# SERVICE BULLETIN

**Service Bulletin No.: DAC1-25-02 Rev 0**

**Title:** ME406 ELT installation for Reverse  
Instrument Panel aircraft

**Figure 1:**

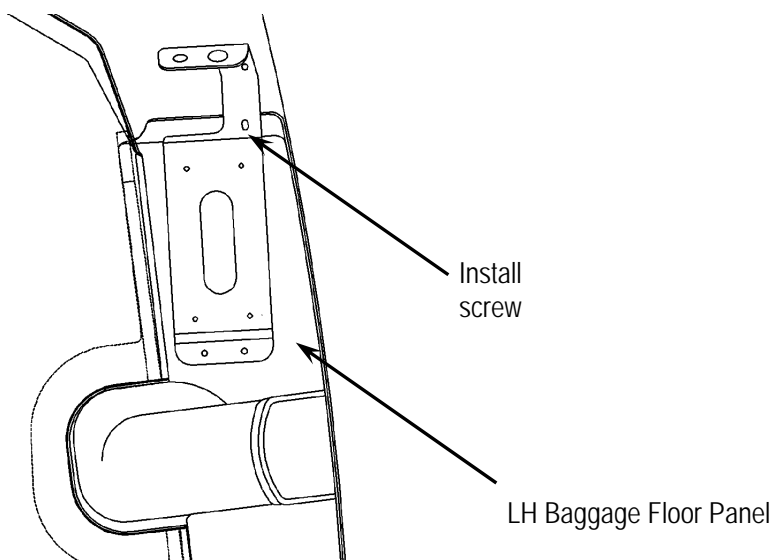
- 10.1** Remove existing EBC502 ELT and ELT tray.  
**Note:** *Before removing ensure ELT switch is in the OFF position.*
- 10.2** Remove AFT attachment screw from LH Baggage Floor Panel and position ELT Bracket Assembly (22-2563-10-00) on LH Baggage Floor Panel as shown on Figure 1. Reinstall screw.

**Figure 2:**

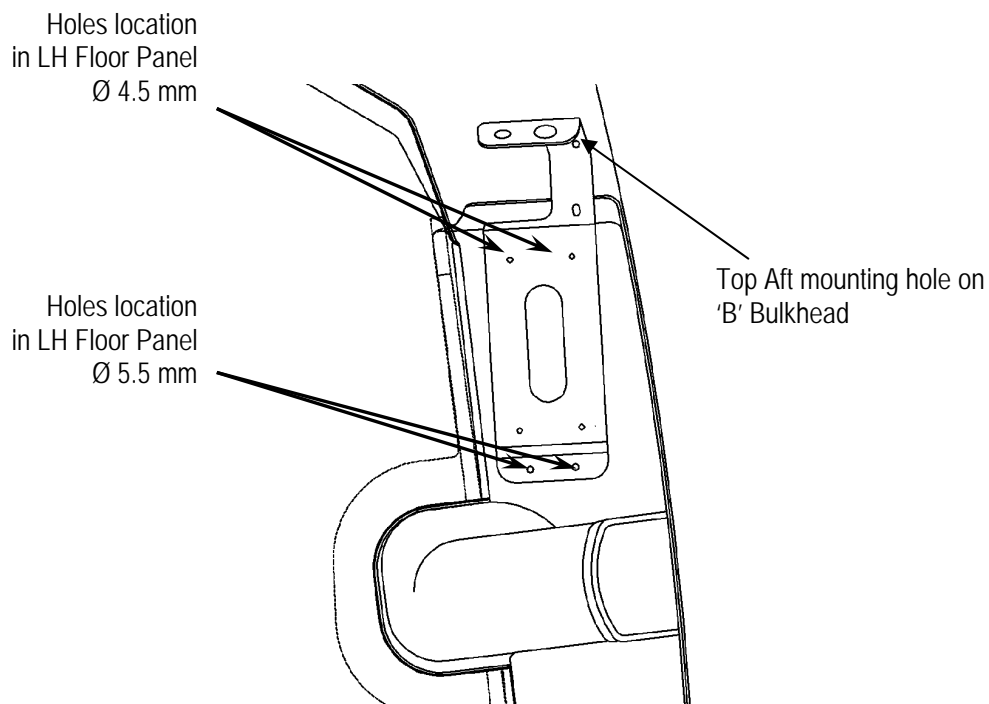
- 10.3** Verify that the bracket is installed within  $\pm 10^\circ$  to aircraft longitudinal axis.
- 10.4** Transfer/drill mounting hole locations (5 locations) from ELT Bracket Assembly to B-Bulkhead and LH Baggage Floor Panel. See Figure 2.  
**NOTE:** *Do not damage structure behind B-Bulkhead.*

**Figure 3:**

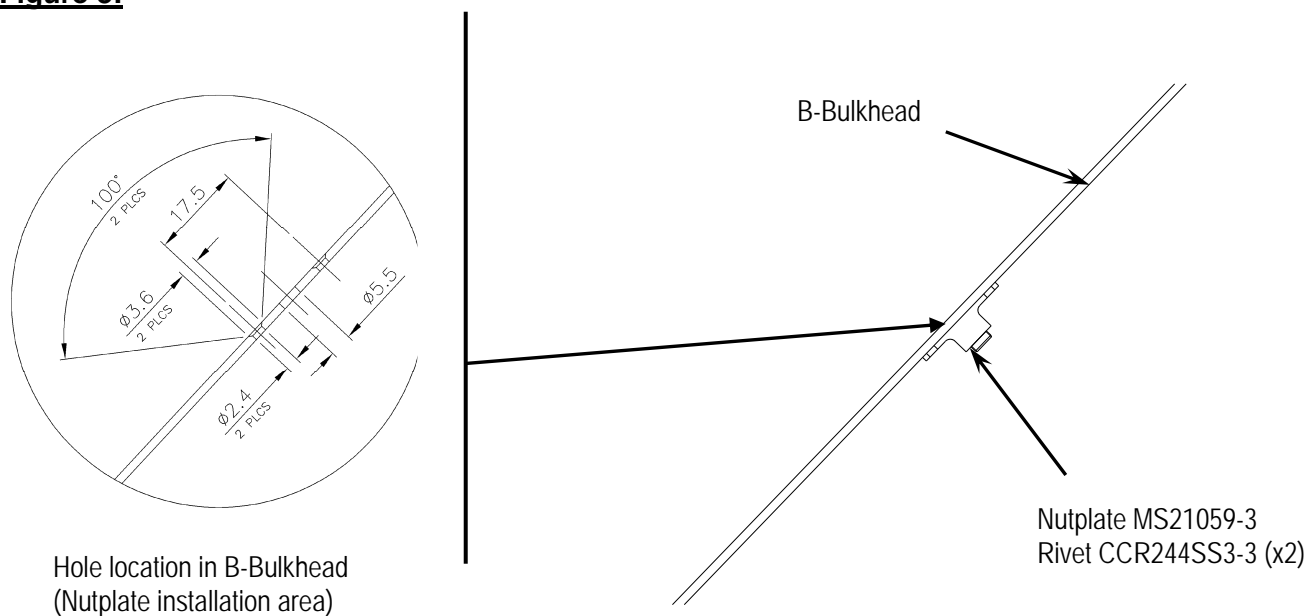
- 10.5** Remove ELT Bracket Assembly and Baggage Floor (Centre and LH Panels). Refer to DA20-C1 AMM Chapter 25-10 for Baggage Floor removal.
- 10.6** Drill out rivet holes and install nutplate in top aft mounting hole as per Figure 3.

**Figure 4:**

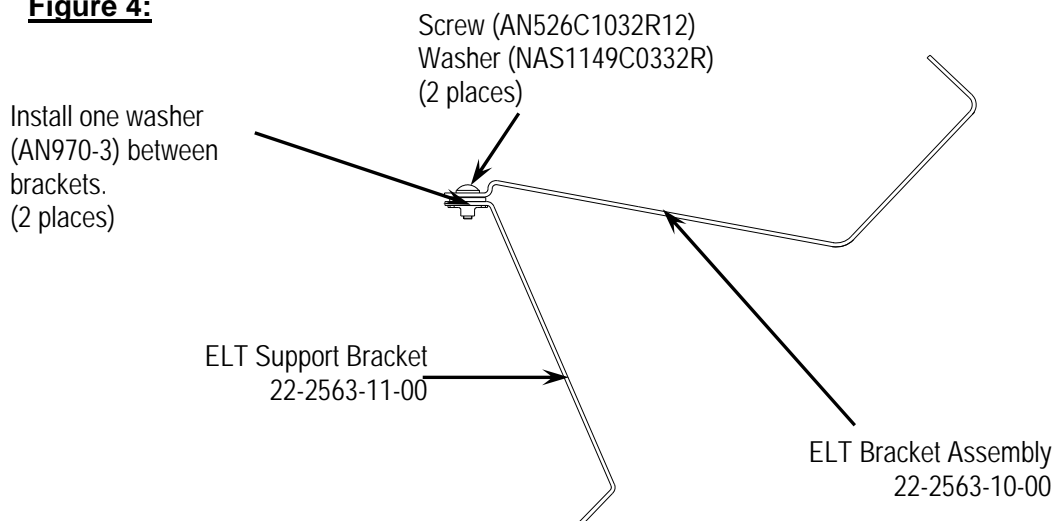
- 10.7** Assemble ELT Bracket Assembly (22-2563-10-00) with ELT Support Bracket Assembly (22-2563-11-00). Use hardware specified in Figure 4. Install a washer (AN970-3) between ELT Bracket Assembly and ELT Support bracket to compensate for Baggage Floor Panel thickness.

**Figure 5:**

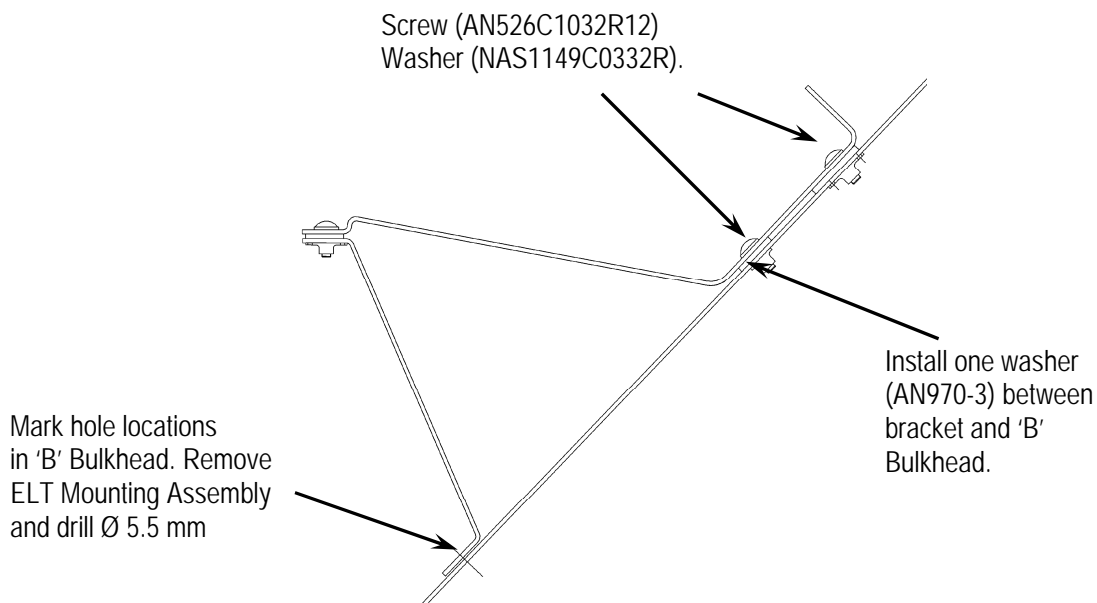
- 10.8** Install ELT Mounting Assembly (ELT Bracket Assembly and Support Bracket) on B-Bulkhead with two aft mounting screws. Install Washer (AN970-3) in lower aft mounting location between ELT Bracket Assembly and B-Bulkhead to compensate for Baggage Floor Panel thickness. See Figure 5.
- 10.9** Temporarily reinstall Centre Baggage Floor Panel on aircraft and verify that forward flange on ELT Bracket Assembly (22-2563-10-00) is in line with Centre Baggage Floor Panel surface. Mark location of bottom mounting holes of Support Bracket Assembly (22-2563-11-00) on B-Bulkhead.
- 10.10** Remove and disassemble ELT Mounting Assembly (discard AN970-3 washers). Remove Centre Baggage Floor Panel.
- 10.11** Drill marked mounting holes in B-Bulkhead. See Figure 5.  
**NOTE: Care should be taken not damage structure behind B-Bulkhead.**

**Figure 6:**

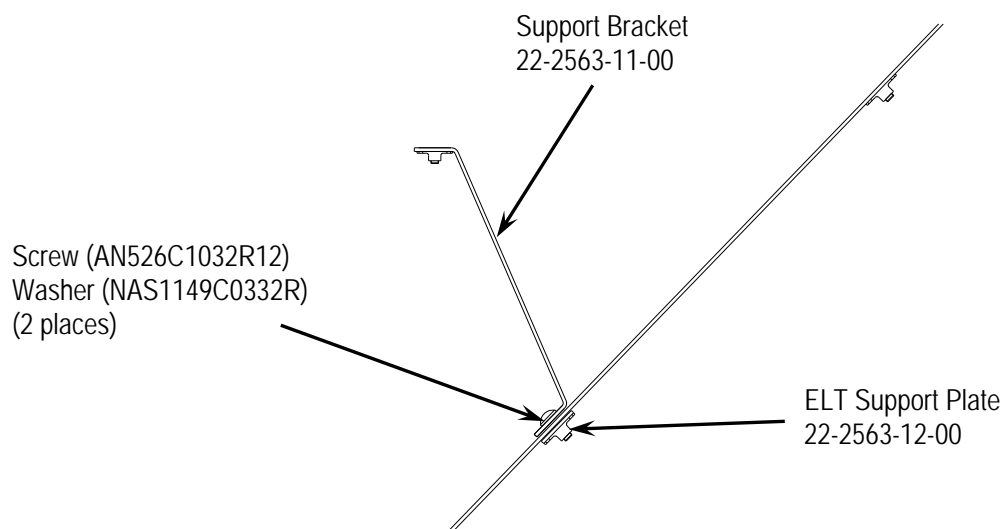
- 10.12** Install Support Bracket (22-2563-11-00) and ELT Support plate (22-2563-12-00) on B-Bulkhead as shown on Figure 6 with hardware provided.

**Figure 7:**

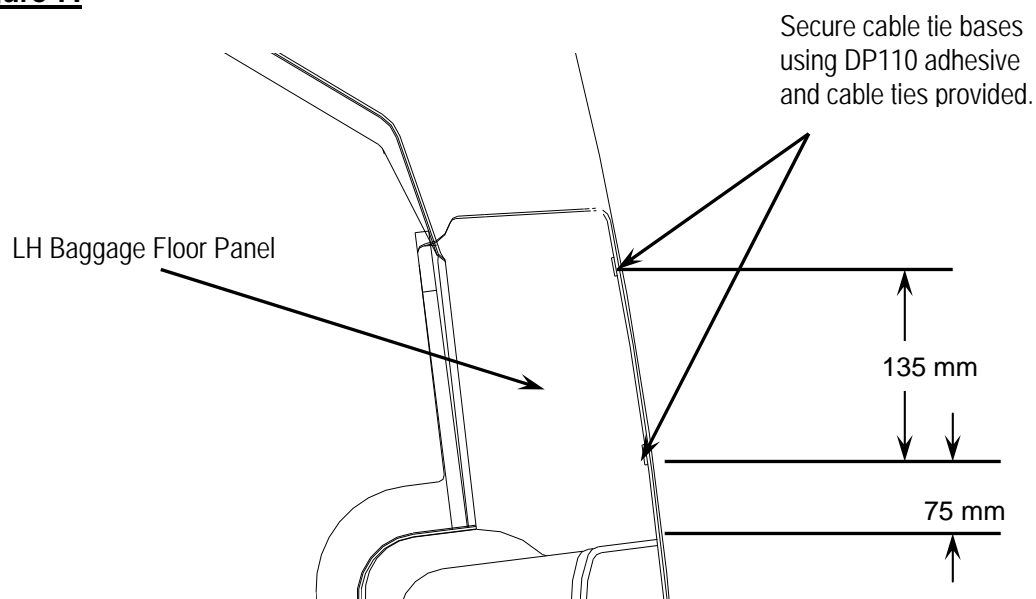
- 10.13** Bond two Cable Tie Bases to LH Baggage Floor Panel outboard flange using DP110 adhesive. See Figure 7.

**Figure 8:**

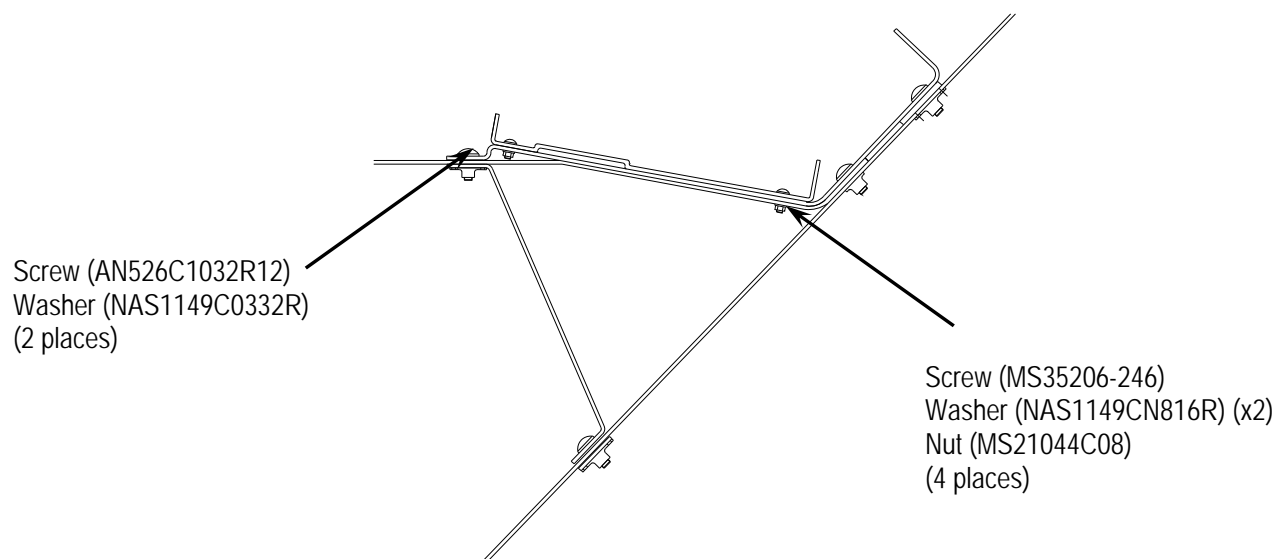
- 10.14** Install ELT Bracket Assembly (22-2563-10-00) and ELT Mounting Tray (452-3034) on LH Baggage Floor Panel using supplied hardware (MS35206-246 screw, NAS1149CN816R washer and MS21044C08 nut). See Figure 8.

**Figure 9:**

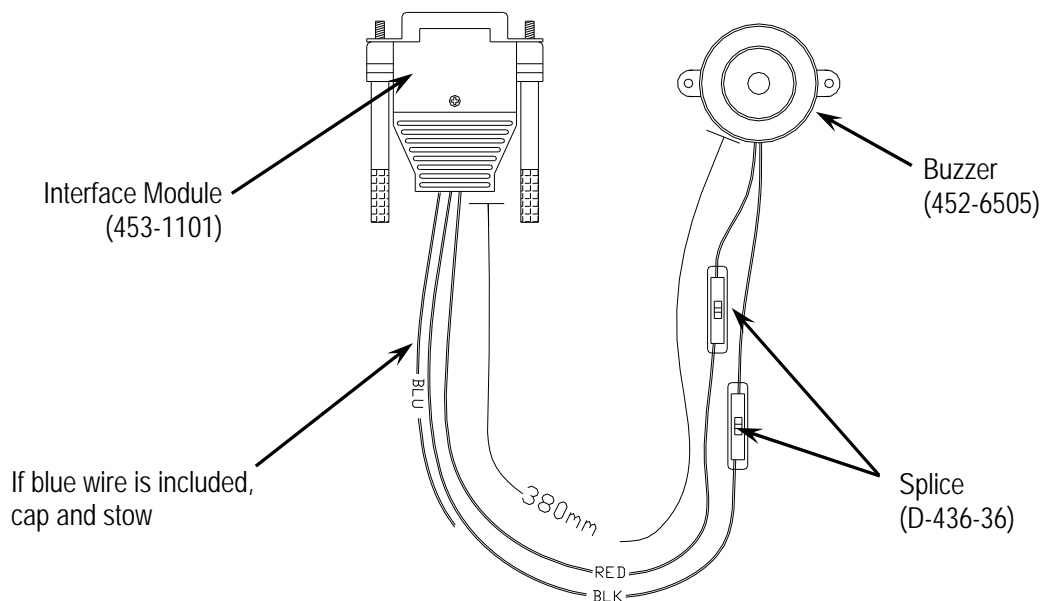
- 10.15** Clean up work area and remove all foreign objects from aircraft.
- 10.16** Install LH Baggage Floor Panel on aircraft in accordance with DA20-C1 AMM Chapter 25-10 and Figure 8.
- 10.17** Install Centre Baggage Floor Panel on aircraft in accordance with DA20-C1 AMM Chapter 25-10.
- 10.18** Splice Artex ELT Interface module to Artex ELT buzzer using splices provided. See Figure 9.

**Figure 10:**

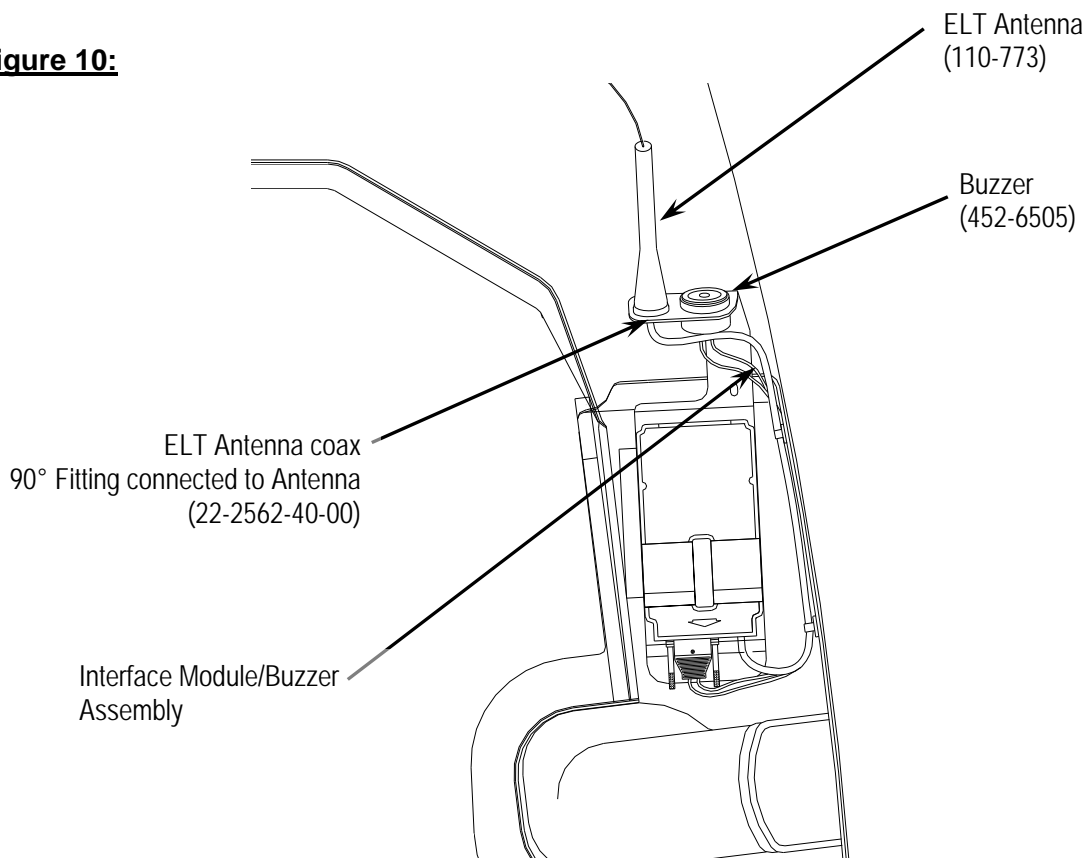
- 10.19** Install Buzzer onto ELT Bracket Assembly (22-2563-10-00) as shown in Figure 10. Route and secure ELT Coax Assembly and Interface module/buzzer by securing them to cable tie bases on LH flange of Baggage floor panel. 90° fitting on ELT Coax Assembly connects to antenna.
- 10.20** Install ELT Antenna (110-773) onto ELT Bracket Assembly (22-2563-10-00) as shown in Figure 10 and connect 90° fitting of ELT Coax Assembly (22-2562-40-00) to it.
